**TOWN OF NEWBURGH  
PLANNING BOARD  
TECHNICAL REVIEW COMMENTS**

**PROJECT: A. DUIE PYLE MAINTENANCE BUILDING**  
**PROJECT NO.: 19-09**  
**PROJECT LOCATION: SECTION 95, BLOCK 1, LOT 69.1 & 79**  
**REVIEW DATE: 11 APRIL 2019**  
**MEETING DATE: 18 APRIL 2019**  
**PROJECT REPRESENTATIVE: LANGDON ENGINEERS/Justin Macalintal, Snr. Staff Engineer**

**Re: A.Duie Pyle Maintenance Building  
Responses to Technical Review Comments  
Project No.:PB 2019-09  
Langan Project No.: 190048601**

Drawing Title: **SITE PLAN**

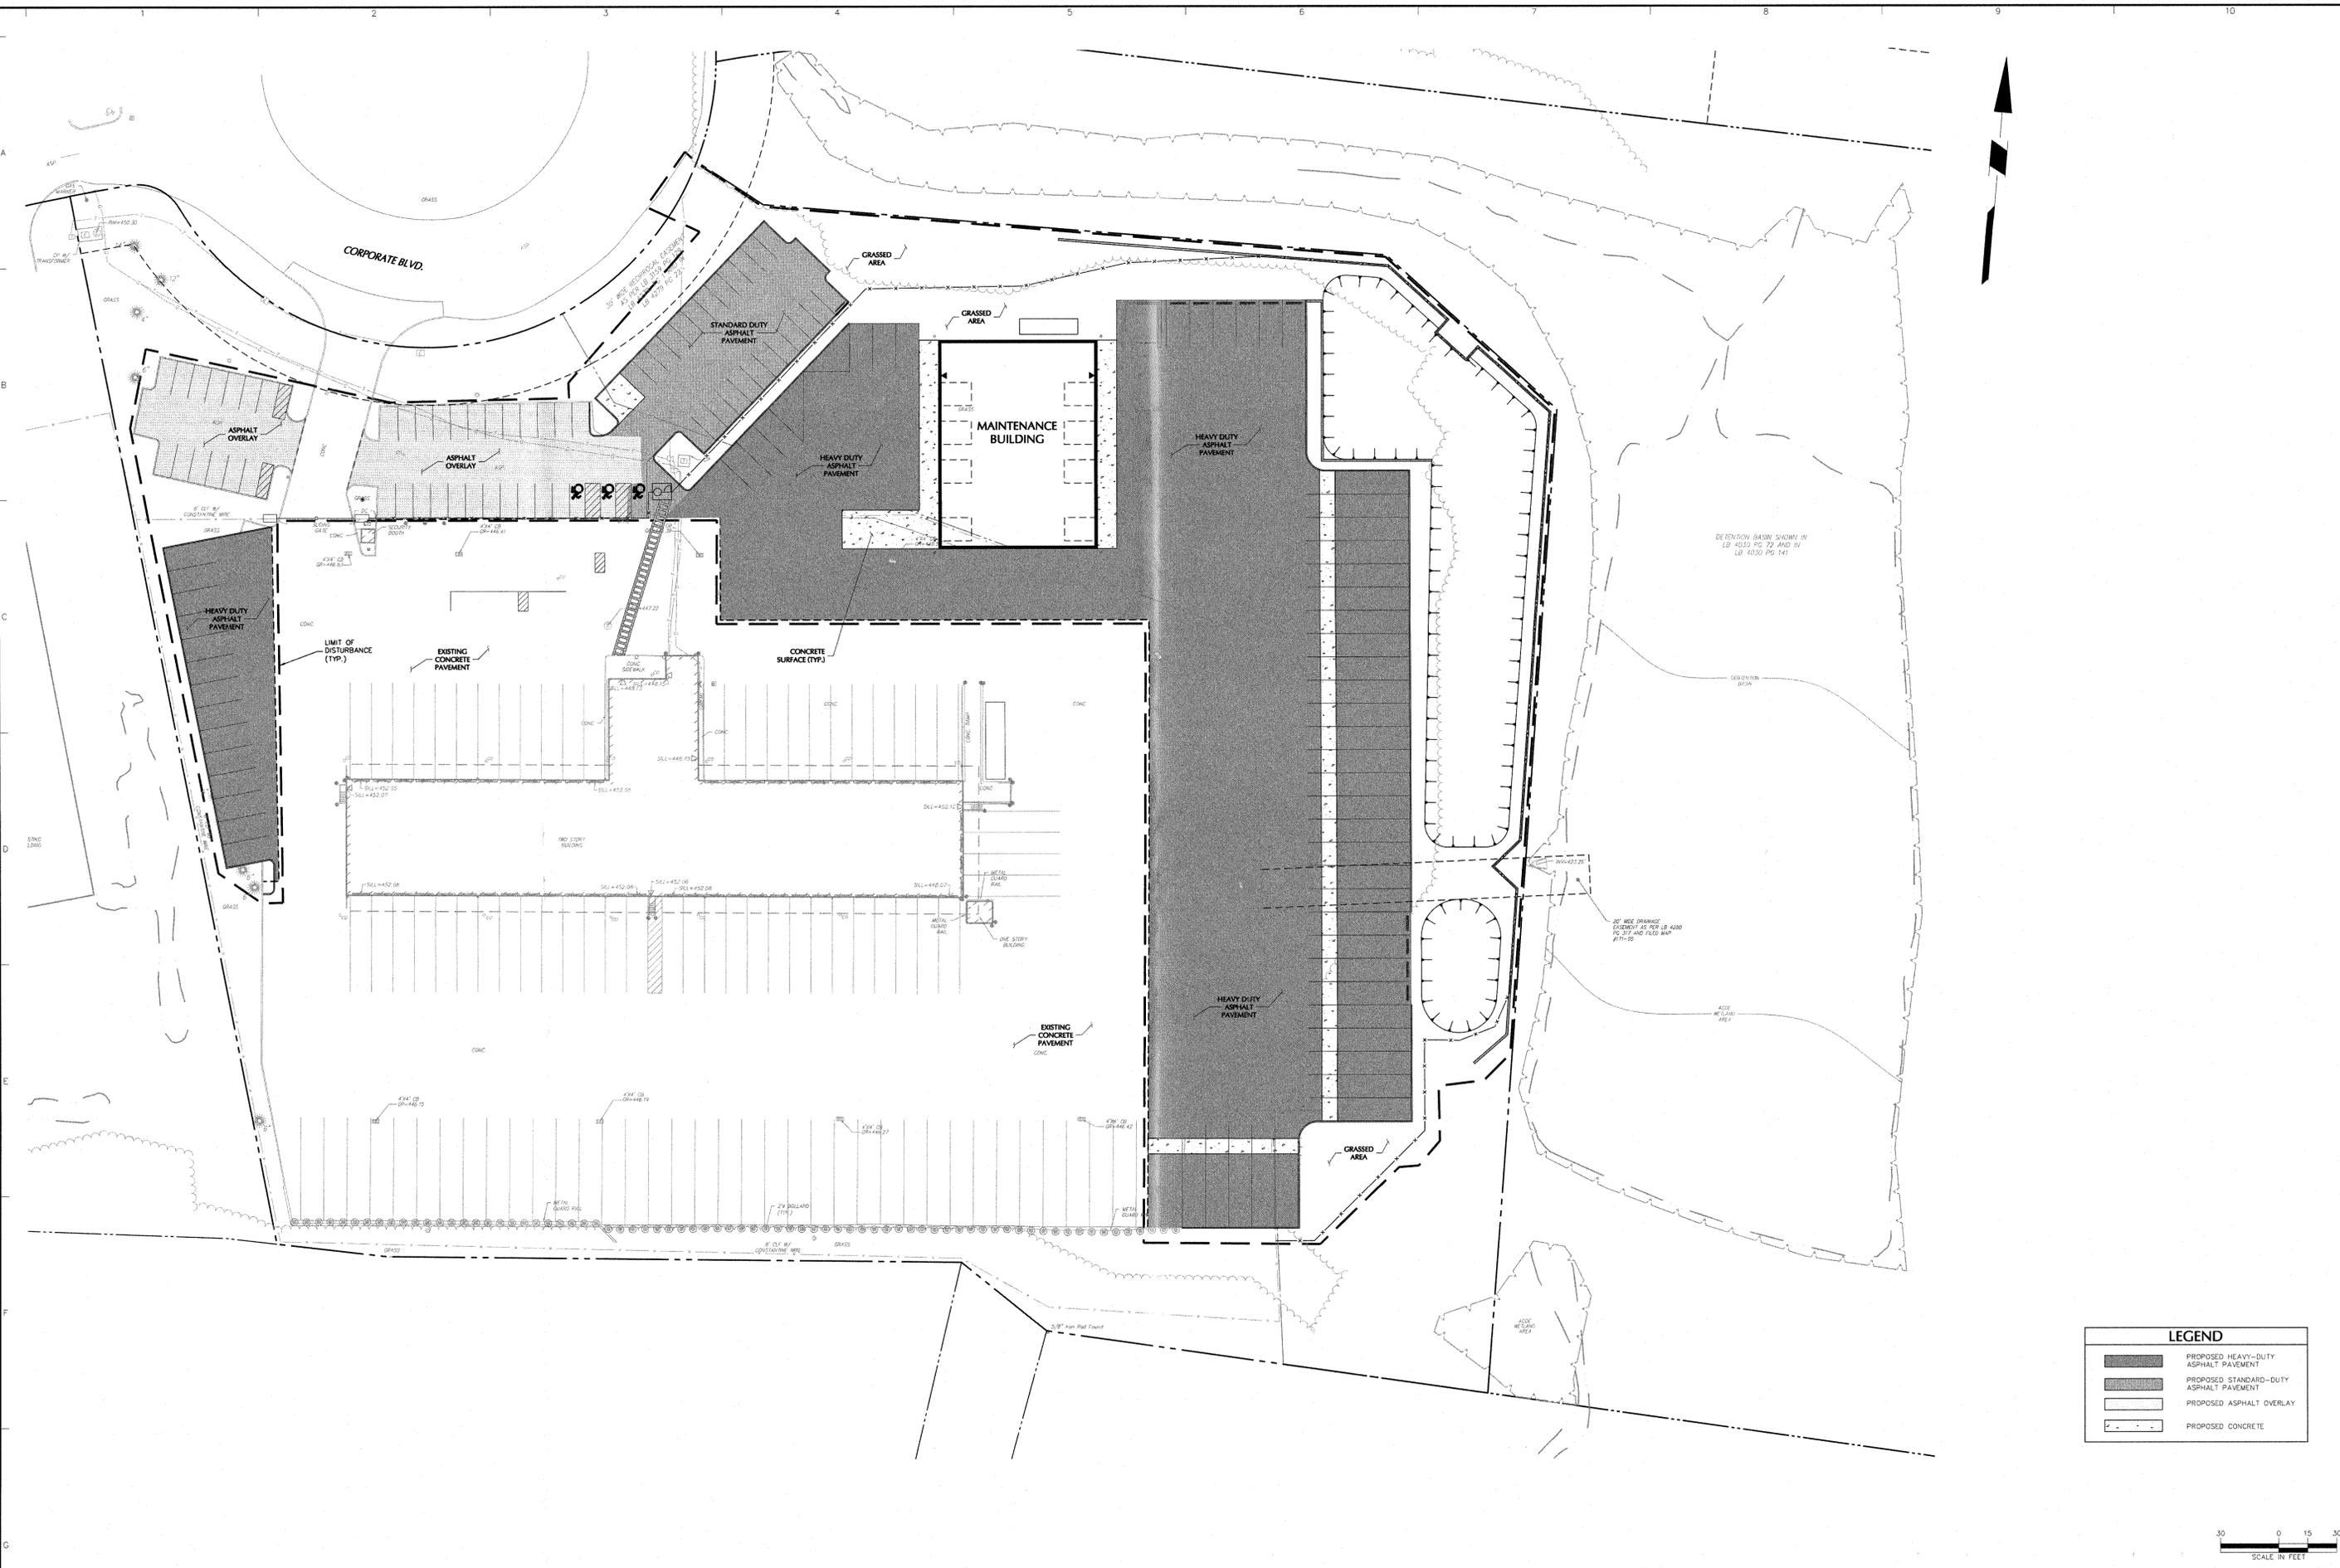
*Comment 1. The existing employee parking lot surface is rough. The plan shows that the existing 23-space lot will be resurfaced, stopping short of the concrete driveway. We recommend that the resurface extend all the way to the concrete driveway, an additional ±260 SF. In addition, the 13-space employee parking lot could use a resurfacing, or at a minimum, the parking stalls restriped to Town standards.*

*Comment 2. The site plan should show new striping for the two existing employee parking lots.*

*Comment 7. Accessible parking spaces are depicted on the opposite side of the fence. Applicants are requested to evaluate the accessible route as a row of parking exists on the interior side of the fence. A gate is identified in this vicinity as well.*

**Response:** The Applicant agrees to mill and overlay the employee parking area in the front of the property. See sheet 4 of 12 of the revised site plans.

**Response:** The plans were revised to show the two existing employee parking lots to be restriped. See sheet 4 of 12 of the revised site plans.

**Response: The site plans were revised to remove employee parking spaces inside the fenced area in order to keep employee traffic and truck traffic separate for safety purposes. The proposed handicap spaces are located next to the proposed turnstile entrance to the facility. See sheet 4 of 12 of the revised site plans.**

**BIORETENTION WITH UNDERDRAIN**

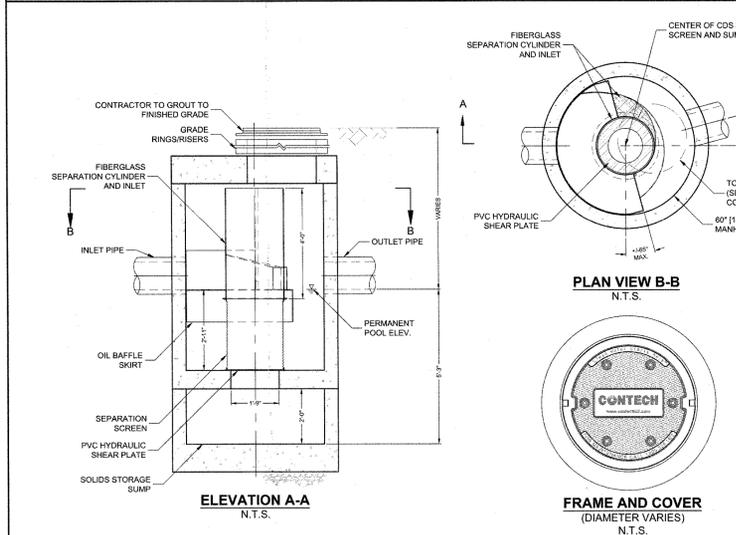
*Comment 8. This office is reviewing a Stormwater Pollution Prevention Plan submitted for the project. Initial review identifies that the project has not been evaluated as a stormwater hot spot in accordance with the NYSDEC design manual Section 4.11. Project design utilizing bio- retention with infiltration practices should be further evaluated.*

**Response: The bioretention basin detail was revised to show a 30 mil PVC liner as accepted by the NYSDEC when treating hot spot runoff. Therefore, the bioretention basin serves as a filtration practice and complies with Section 4.11 of the NYSDEC Design Manual.**

**TYPICAL SEGMENTAL BLOCK RETAINING WALL**

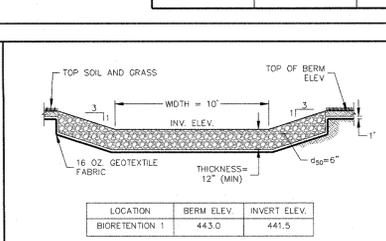
*Comment 11. Extensive retaining walls are proposed along the eastern portion of the site. Design of these retaining walls should be incorporated into the plan sheets. An evaluation as to the impacts of the retaining wall on Stormwater Management Facilities located in close proximity should be prepared.*

**Response:** The site plan was revised to include a segmental block wall detail. The structural design of the retaining wall will be included with our application for building permit.

**THRUST BLOCKS**  
SCALE: NTS

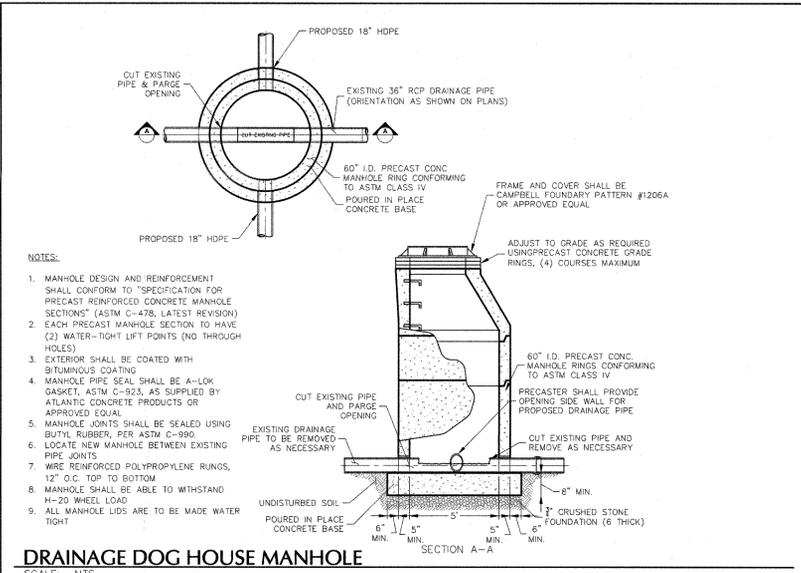
1. Detail Sheets contain a detail for thrust blocks. Town of Newburgh requires restrain joint pipe. Restrain joint pipe details and chart should be added to the plans.

**FIRE/POTABLE WATER SERVICE**  
SCALE: NTS

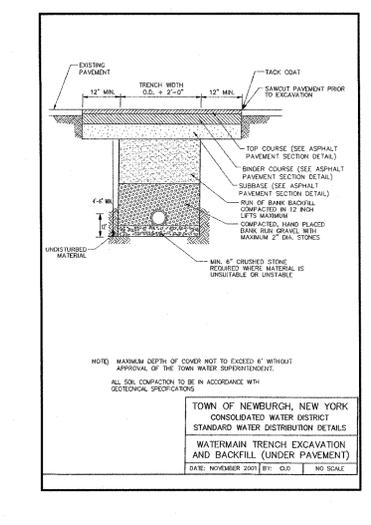
2. Fire/potable water service detail does not comply with Town of Newburgh standards. The fire shut off valve must be located upstream of the potable water valve such that potable water is terminated when fire service supply is terminated.

*Comment 2. Water connection to the building must be designed to separate the fire flow and potable water systems whereby if fire flow systems are terminated potable water to the building is terminated. Typical detail for Town of Newburgh is required.*

**Response:** The utility plan was revised to show separate fire flow and potable water service lines to the proposed maintenance building. Water utility details for the Town of Newburgh were added to the detail sheets.

**SANITARY SEWER PUMP (E/ONE MODEL #WH231 OR APPROVED EQUAL)**  
SCALE: NTS

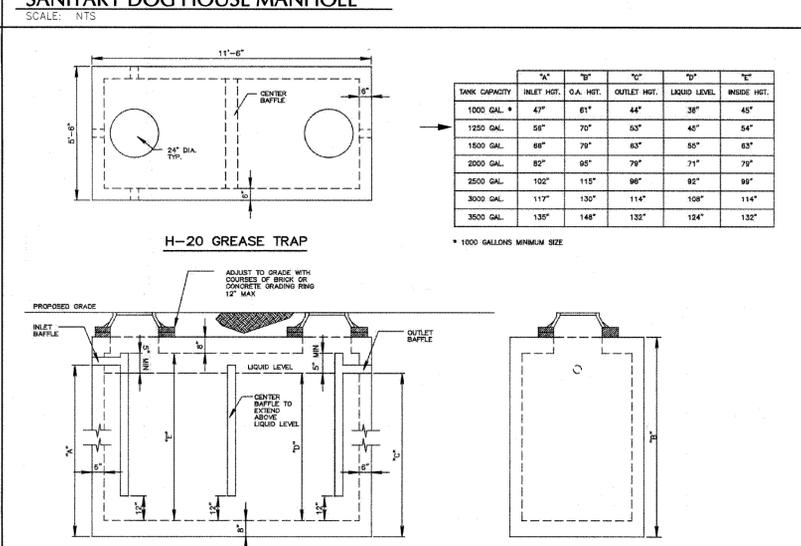
5. The specified pump station appears to have a 4 inch DWV pipe inlet connection while plans identify a minimum 6 inch diameter SDR35 pipe.
6. Previous comment identified the discharge of the emergency spillway at the retaining wall. Response identifies that rip rap will be provided at base of wall. This should be depicted on the Grading and Drainage Plan.

*Comment 3. Sanitary sewer design incorporates a proposed oil/water separator and pump station with force main. Design report and design details for this must be provided. Sizing of the oil/water separator as well as design of all the pump station must be included.*

**Response:** The proposed oil/water separator and pump station were designed based on an anticipated sanitary demand of 800± gallons per day. The project will include an oil/water separator with a 1,250 gallon capacity (50% additional reserve capacity over sanitary demand) and a low pressure pump station (E/One Model WH231 or approved equal) capable of conveying 850 gallons per day.
